New York 3/14/23
3 A.M.

Dear Miss Morgan

Some Notes on Interior M.B.

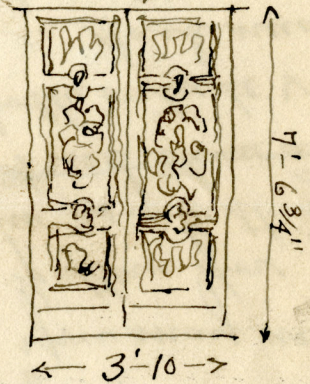
- PP Wire for center lights in sitting Room & Loggia
- Place plenty of base plugs. 2 bracket lights at sides of each tapestry in sitting Room
10. The Bed Room & Bath room windows that show on side elevation (in walls opposite sitting Room) to be small & separate with central balcony

Mr Hearst does not like an all glass feeling in a bed room wall
